Bulletin

MODEL: BENTLEY MARK VI

MODIFICATION.

REAR BRAKE EQUALISER.

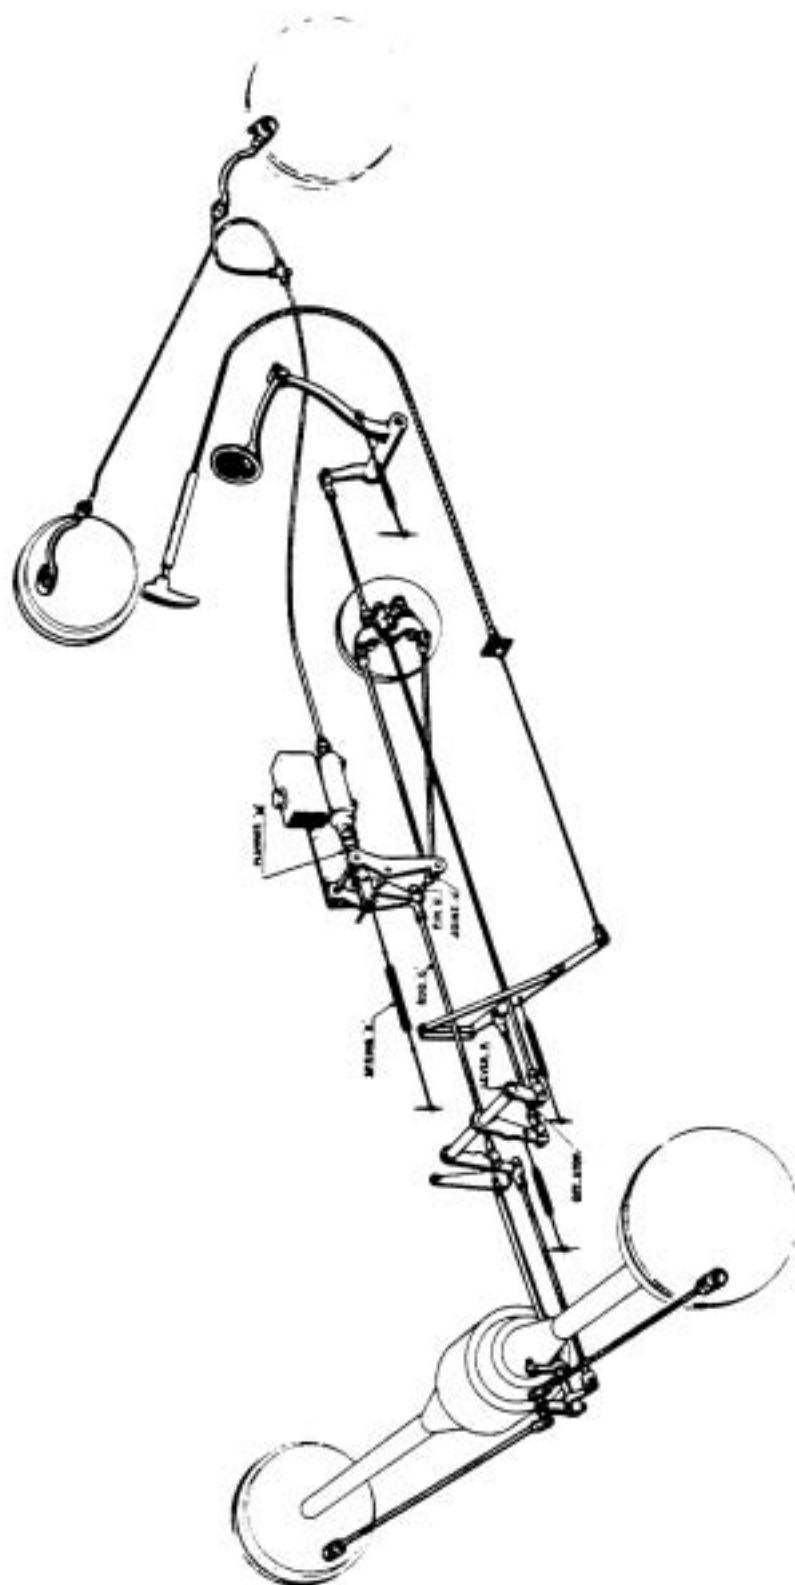
A modification is introduced to reduce a mechanical noise that can more accurately be described as a "clonk" from the brake linkage which may occur on application of the brakes.

In many cases, the origin of this noise has been traced to excessive free travel between the plunger and piston of the brake master cylinder, and adjustment of the brake linkage as described hereunder, has in certain instances effected a noticeable reduction of the noise.

The attached drawing shows the linkage involved in carrying out this adjustment:-

1. Ensure that the rear brakes are in the OFF position and that the lever 'R' is against its OFF stop.
2. Remove the master cylinder pull-off spring 'X' and the clevis pin 'D'.
3. Adjust the rod 'C' so that the joint 'J' has zero to .050" free travel before the plunger 'M' contacts the master cylinder piston.
4. Tighten the locknut on the rod 'C'. Replace the clevis pin 'D' and the master cylinder pull-off spring 'X'.

FIG. 1.

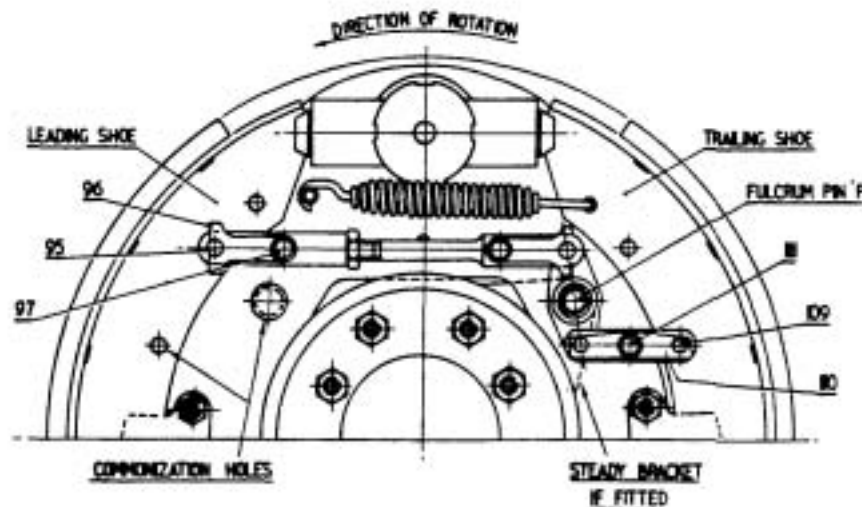
Instances have occurred in service with the Bentley Mark VI, where the front brakes have failed to release properly after application. This "Spragging" of the front brakes is due to an excessive self-servo action of the shoes, and manifests itself by a locking of the brakes even after the foot pedal has been released. In all such cases, the following modification should be carried out.

REMOVAL OF EQUAL WEAR LINKAGE (FIG.1).

- (a) Remove setscrew and spring washer (111) and the locking plate (110) and by easing the load from the pull-off spring, withdraw pin (109).
- (b) Remove setscrew and spring washer (97) and locking plate (96) and withdraw pin (95).
- (c) Remove equal wear linkage from fulcrum pin (P) complete.

FIG. 2.

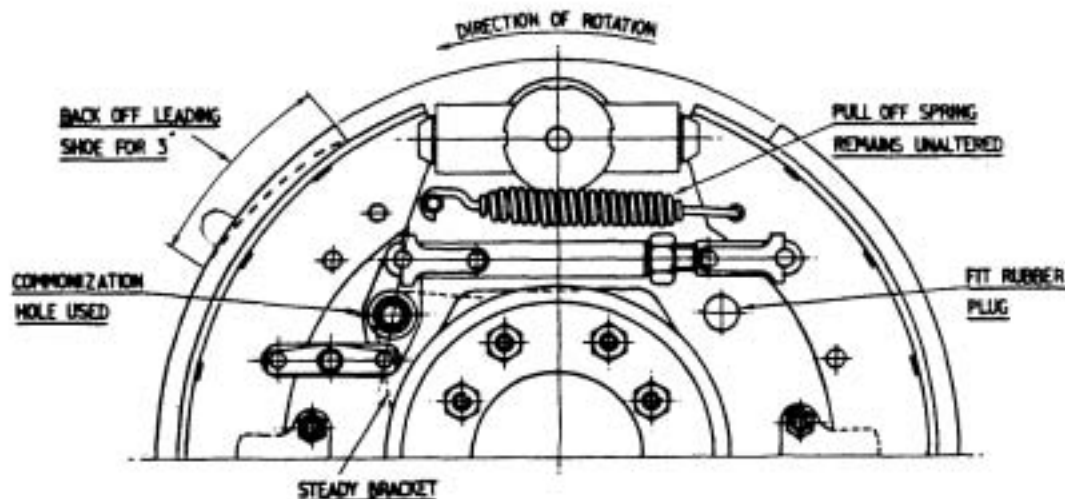
REPLACEMENT OF EQUAL WEAR LINKAGE:

- (a) Replace the existing push rod and jaw of the equal wear assembly with the strengthened parts Nos. RG-6045/6 and nut K-4040/Z.
 NOTE: If these parts are not available, the existing push rod and jaw may be used, but should be replaced at the first opportunity.
- (b) Invert equal wear linkage assembly, and replace on fulcrum pin (P). (The short link should now be to the front of the car, and will line up with the lowest of the three top holes in the leading shoe, and the push rod will be to the rear and will line with the second hole from the top in the trailing shoe).
- (c) Replace pin (109) in the short link, locking plate (110) and the setscrew and spring washer (111).

- (d) Replace pin (95) in the push rod, locking plate (96), and the setscrew and spring washer (97).
- (e) On cars fitted with the steady bracket, the grease catcher assembly from the left-hand wheel must be replaced on the right-hand wheel and vice-versa.
- (f) Replace the front hubs, and secure the retaining nut and washer.

FIG. 3.

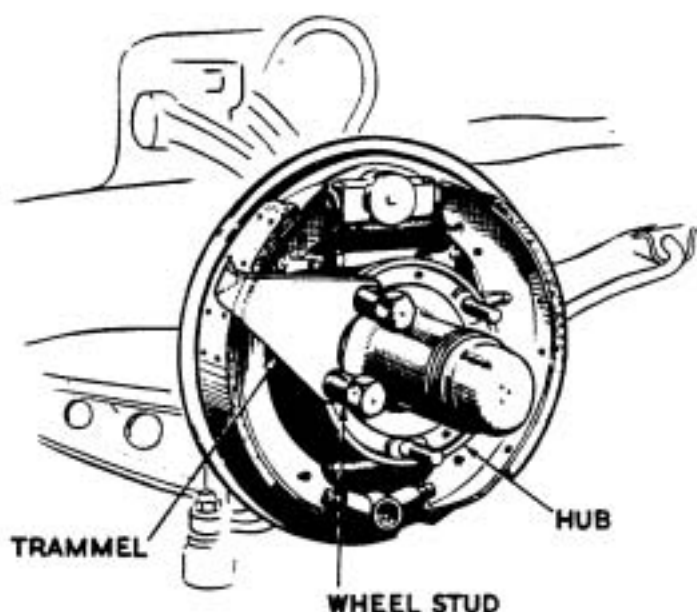
CENTRALIZATION OF BRAKE SHOES:

- (a) From a piece of light gauge steel, make up a trammel as shown in (FIG. 3) to fit over two of the wheel studs on the hub, and bend the pointer to touch lightly on the face of the brake linings.

- (b) Temporarily replace the brake drum, and after operating front brakes from the master cylinder, externally adjust front brake shoes.
- (c) Remove brake drums and fit trammel on any two wheel studs.
- (d) By making suitable adjustments to the brake equalizer push rod, centralize the brake shoes, rotating the trammel about the shoes as a gauge.
- (e) When shoes are centralized, tighten the locknut on the push rod, and replace brake drums and road wheels.
- (f) Finally check external adjustment of brakes.

FIG. 1. FITTING OF UNDERSHIELD.

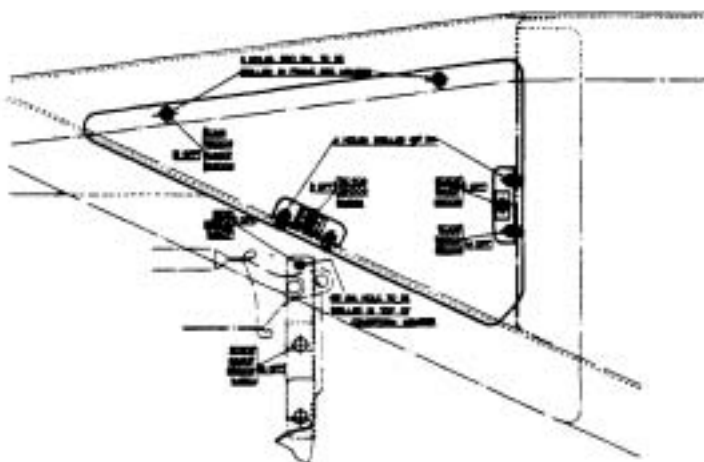
Current Bentley chassis in production are provided with protection against the possible loss in servo efficiency in wet weather, due to water finding its way on to the friction surfaces.

This protection consists of an additional undershield, which is fitted over the existing triangular gap formed between the frame side member and the cruciform member forward of the battery container, together with a vertical baffle plate located just in front of the servo unit itself.

This modification is now offered as a chargeable improvement for fitting to existing models of earlier chassis, and its incorporation is recommended in all cases where servo inefficiency is traced to water on the friction faces.

1. Place the car over a pit, or elevate on a suitable hoist.
2. Remove the battery.
3. Remove the existing right-hand rear undershield immediately below the servo unit.
4. Offer up the new undershield from below the chassis and cover the triangular gap formed by the frame side member and cruciform member forward of the battery container. Mark off the relative positions for the two

bolt holes in the lower flange of the frame side member, also for the two supporting brackets as shown in Fig.1. Drill the two 0.250" dia. bolt holes in the frame side member.

5. Drill the blank flange of each bracket assembly to accommodate two 2-BA securing bolts respectively. Offer up the brackets in position on the cruciform and gusset respectively and mark off for the 2-BA securing bolt holes. Drill the two members accordingly and secure the brackets.
- NOTE: Certain chassis will be found to have these brackets already fitted.

7. Offer up the baffle plate with its flanges towards the engine, forward of the servo unit, and mate the head of the leading rivet securing the spring clip to the top of the cruciform with the radiused slot cut in the top flange of the plate. Mark off the relative position for the 2-BA bolt hole in the top of the cruciform as shown in Fig.1. Drill accordingly.

FIG. 2. BAFFLE PLATE.

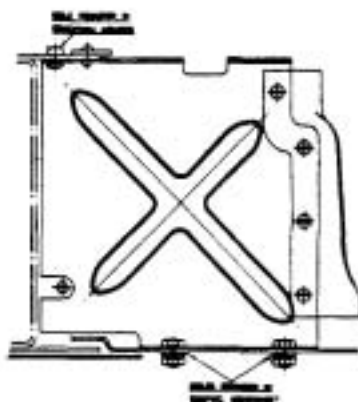
8. Fit the rubber protection piece to the baffle plate as shown in Fig.2.

Both the rubber and the retaining strip should be fitted on the ENGINE side of the plate, with the nuts for the securing screws on the obverse face.

9. Fit the baffle plate to the cruciform, and then reposition the existing rear undershield temporarily below the servo unit. Mark off the undershield to correspond with the two 0.250" dia. bolt holes in the lower flange of the baffle plate. Remove the undershield and drill accordingly. Refit the undershield and bolt this to the lower flange of the baffle plate, using the two set bolts provided.

FIG. 1 FITTING OF UNDER-FRAME COVER PLATE.

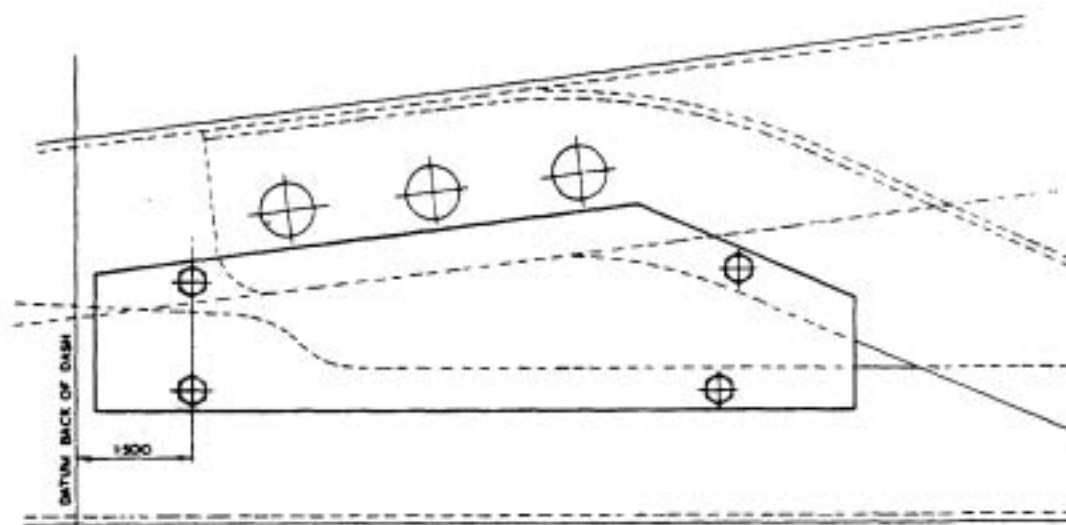
Further to the above, it is recommended that additional protection plates for the throttle control countershaft on the right-hand side frame member are also fitted whenever this modification is incorporated on early type chassis.

1. Fit the under-frame cover plate (RP-6209) as shown in Fig. 1.
 - a) Offer up the plate, and mark off the relative positions for the four retaining setscrews.
 - b) Drill the four holes 0.1562" dia., and then tap 2 BA (31 T.P.I. R/H).
 - c) Fit the cover plate.

FIG. 2. METHOD OF FIXING COVER PLATE OVER HAND-HOLE.

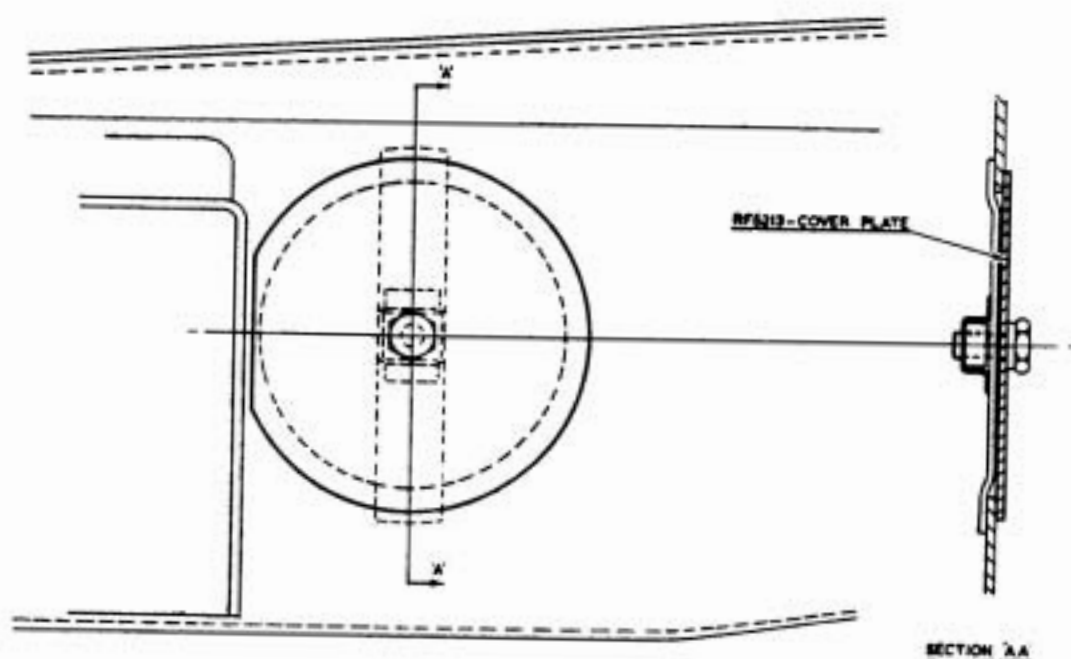
2. Fit the hand-hole cover plate (RF-6213) as shown in Fig. 2.

FIG. 1. DIAGRAM - SETTING INSTRUCTIONS - FRONT BRAKES.

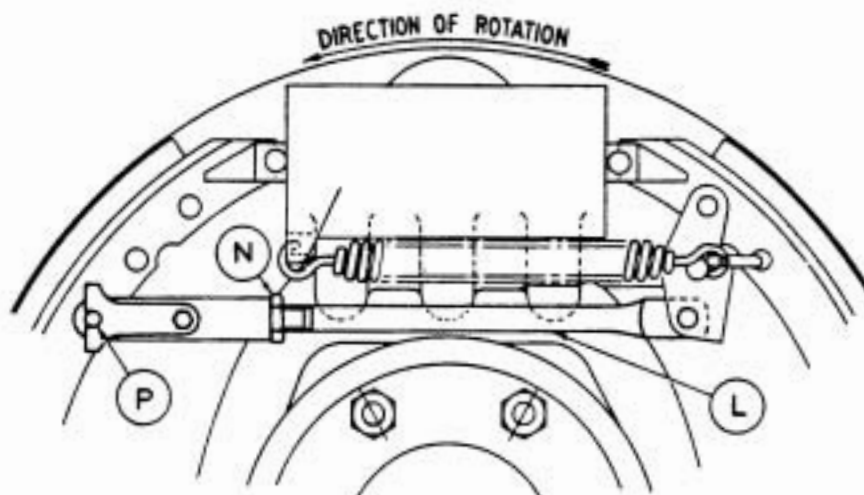
Commencing G Series, i.e. Chassis No.B-1-GT, and onwards, new front brakes are fitted which differ from the front brakes fitted to chassis prior to 'G' series, chiefly in the use of an internal hydraulic cylinder, which acts directly on the shoes in place of an external cylinder(expander) operating the shoes through a wedge mechanism.

The brake cylinder follows standard practice, and contains the usual two rubber cups and pistons, with expander spring between. The pistons act on the shoe tips through short push rods, which pass through rubber dust excluders in the ends of the cylinder. Unlike the previous brake, the cylinder body is rigidly attached to the carrier plate by three studs. The holes for the studs in the carrier plate are elongated so that the cylinder can be centralised during initial assembly, but after this operation has been carried out, the cylinder is securely locked to the carrier plate by fully tightening the studs. Although the cylinder body is fixed, the loads on the two shoe tips are nevertheless balanced by virtue of the column of oil between the two pistons.

The equal wear linkage between the two shoes also differs from the previous arrangement. The shorter of the two links is now eliminated, one arm of the balance lever being attached directly to the web of the trailing shoe, while a long link connects the other arm to the web of the leading shoe. (See Fig.1). The balance lever, instead of having a fulcrum consisting of a pin attached to the carrier plate, is pivoted on the end of a short push rod which butts against the cylinder body. The pull-off spring is also attached to the cylinder body, so that the whole assembly of shoes and inter-shoe linkage is mounted off the cylinder, and will slide bodily if the three studs attaching the cylinder to the carrier plate are loosened. The bedding of the two shoes can thus be equalised without any adjustment of the inter-shoe linkage being necessary, as was the case on the previous brake. The long link of the inter-shoe linkage is still adjustable, but this merely provides for an initial "sizing" operation to set the brake to the correct diameter over the linings to suit the drum. (See setting instructions.) The shoes have rather narrower webs than formerly, to provide a certain degree of flexibility. The same adjuster unit is used exactly as before.

- (i) Build up the brake complete, but do not fit the locking plate for pin P, Fig. 1, or lock the nut N. For an initial setting, the link L, should be adjusted to 7.375" (187.3 mm) between the pin centres.

- (ii) Screw back the hand adjuster as far as it will go, and slacken off the two setscrews securing the adjuster unit to the carrier plate.
- (iii) Slacken off the three nuts securing the hydraulic cylinder unit to the carrier plate, so that it is free to float.

- (iv) Fit the brake drum to the hub. If the drum cannot be fitted over the shoes, lengthen the link L, until it can. This is most easily done by first detaching the pull-off spring, when the pin P can easily be withdrawn.

- (v) With the drum in position, check the total number of "CLICKS" obtainable on the adjuster in bringing the shoes into contact with the drum, which should be between 9 and 15.

- (vi) If more than 15 "CLICKS" are obtained, remove the drum, shorten the link L, and try again. If less than 9 "CLICKS" are obtained, lengthen the link L, and try again. One complete turn of the jaw on link L, corresponds to about 3 "CLICKS" of the adjuster.

- (vii) When the correct length of link L, is obtained, and with the drum still in position, centralise the assembly by screwing up the adjuster until the shoes are hard against the drum and then fully tighten the three nuts securing the hydraulic cylinder unit to the carrier plate, and the two setscrew securing the adjuster unit to the carrier plate.

FIG. 2. FINAL POSITION FOR
MODIFIED SUPPORT.

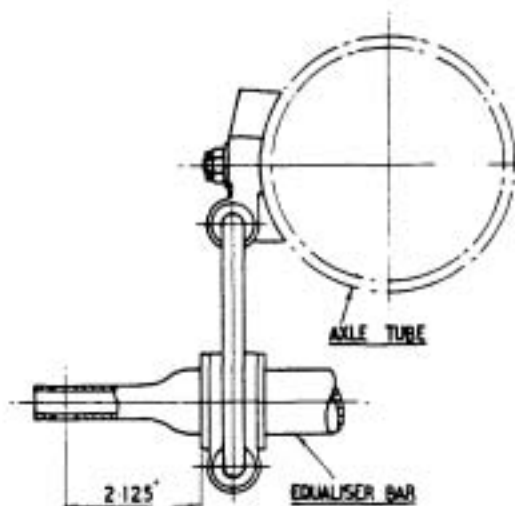
Instances have occurred where the rubber support (RG-3552) for the rear brake equaliser bar has fractured on existing Bentley Mark VI cars in service.

In order to obviate this a modified type of support assembly has now been introduced for incorporation under the following conditions:-

The modified type support assembly, illustrated in Fig.1 above, consists of a "U" shaped metal link, which is retained at either end by brackets in silentbloc bushes. The upper bracket has a radiused face to correspond with the outside of the rear axle tube, while the lower bracket carries another silentbloc bush through which the equaliser bar passes.

- (3) Thread on the new support assembly from the front end of the equaliser bar, and slide the assembly along the bar until the outer face of the silentbloc bush is exactly $2\frac{1}{25}$ " distant from the centre of the bolt hole at the rear of the bar (See Fig. 2. above). Due to the interference between the rubber bush and the bar, it is recommended that some form of lubricant, e.g. French chalk or soap, is used to facilitate sliding the assembly along the bar.
 - (4) Fit the upper bracket to the existing stud on the axle tube, replace the existing plain washer (distance piece), and then secure by means of the thinner castellated nut provided, locking this by fitting a new $1/16$ " split pin. Reconnect the equaliser bar.
- NOTE: - Constructional variations in the rear axle tube may result in

a "forging flash" preventing the radiused face of the upper support bracket seating correctly when finally assembled. In such cases the "forging flash" should be removed from that part on which the bracket seats to ensure a true bedding between the two mating faces. Under NO circumstances must any metal be removed from the radiused face of the upper bracket as this has been filed to a gauge prior to delivery.

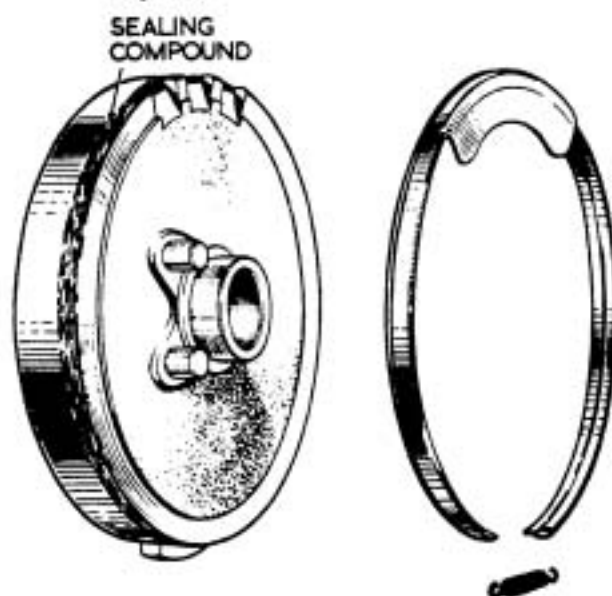
In order to prevent the possibility of oil seepage into the servo motor, the joint between the flange of the spring backing plate and the pressure plate is being coated with "Wellseal" on current production. "Wellseal" is a sealing compound with a rubber solution base which remains soft and pliable when dry.

Retailers are advised that, whenever a servo motor is removed for overhaul or other reason, it should be treated with "Wellseal" or an equivalent compound. After assembling the servo in the usual way, but before fitting the protector ring, the compound should be applied with a thin brush as shown in the illustration.

No further sealing is necessary. The drain holes at the bottom of the spring plate flange and the ventilation slots at the top of the pressure plate, which are covered by the water excluder attached to the protector ring, must be kept clear.

FIG.1. EXPLODED VIEW OF SERVO MOTOR.

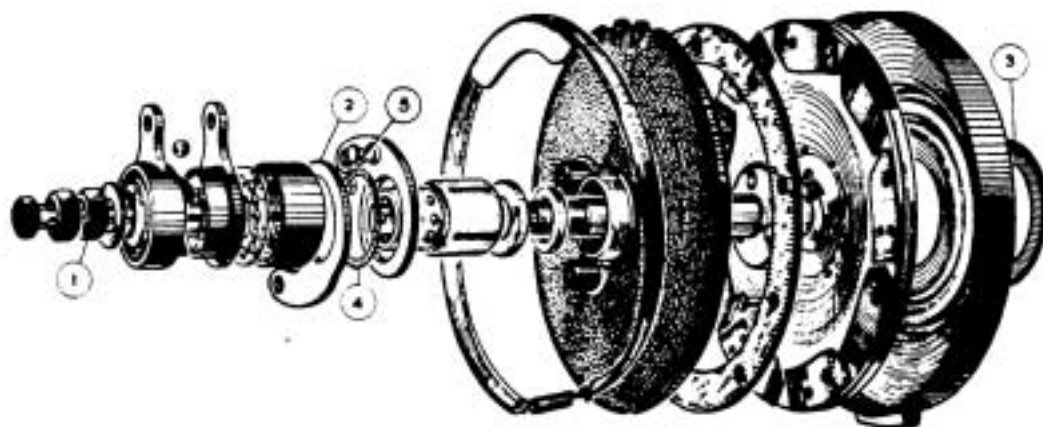
A corrugated washer, Part No. R.5037, has been developed to overcome cases of servo judder on brake application. The washer is fitted between the brake actuating levers in place of the plain washer GB.5083 and effectively damps the servo output to prevent minor fluctuations in the brake linkage from developing into judder.

On all early series cars the corrugated washer can be fitted without further modification, except from approximately B-152-UM onwards when the loading of the servo motor spring back plate was increased from 25 to 40 lbs. With the heavier load spring plate a thinner servo drive sealing washer R.5285 must be fitted in place of the Ferodo washer between the spring plate and the gearbox. This ensures that the combined end thrust of the spring plate and corrugated washer is not sufficient to prevent the brake actuating levers from returning to their off-stop on releasing the brake pedal.

1. Adjusting Nut.
2. Brake Actuating Levers.
3. Ferodo Washer (To be replaced by R.5285 if necessary).
4. Plain Washer GB.5083 (To be replaced by R.5037).
5. Spring Clip (To be removed).

FIG.2.

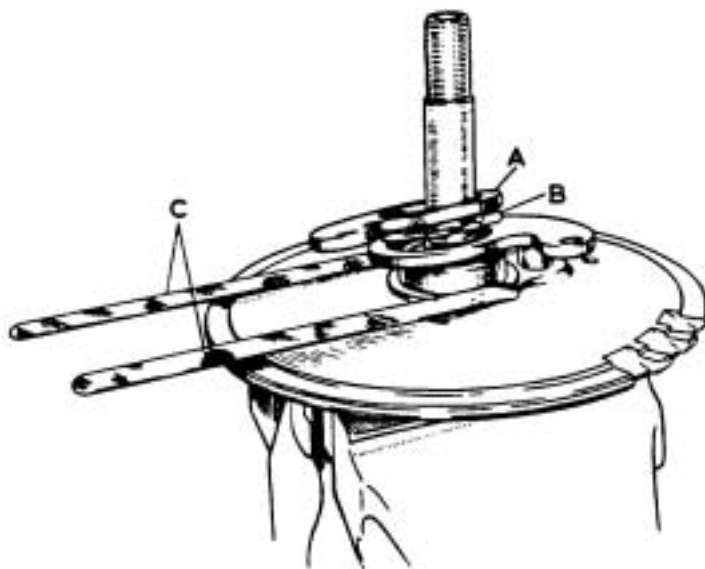
The complete servo motor is to be removed, dismantled, and a packing washer approximately .0625" thick placed between the pressure plate

and the flange on the servo shaft. The servo is then placed in a vice as shown (Fig.2), the corrugated washer fitted into position, and the servo assembled. The adjusting nut is tightened fully home, thus compressing the corrugated washer.

FIG.3.

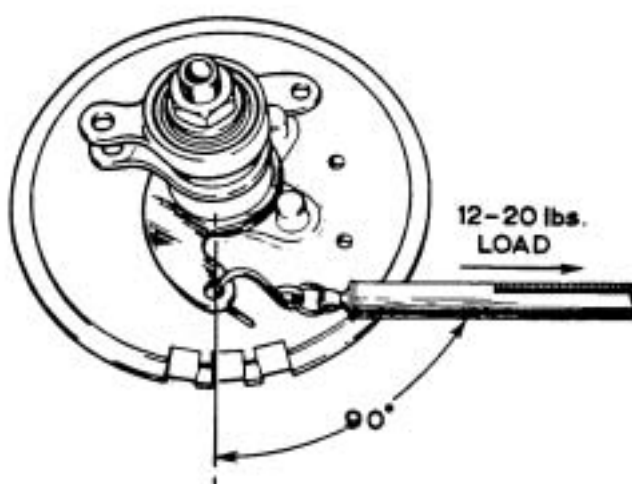
A spring balance is then attached to the brake actuating lever and the poundage figure accurately taken; this must be between 12 and 20 lbs (Fig.3).

If the figure is too high, the adjusting nut must be slackened, two feeler gauges (approximately 0.002" for every 5 lbs in excess poundage) placed between the lower brake actuating lever and the servo pressure plate and the adjusting nut tightened fully once more. This will compress the corrugated washer still further, so that when the feeler gauges are removed

and the adjusting nut re-tightened, a lower poundage figure will be recorded. This must be done, by increasing the feeler gauge thickness, until the brake actuating lever poundage is satisfactory.
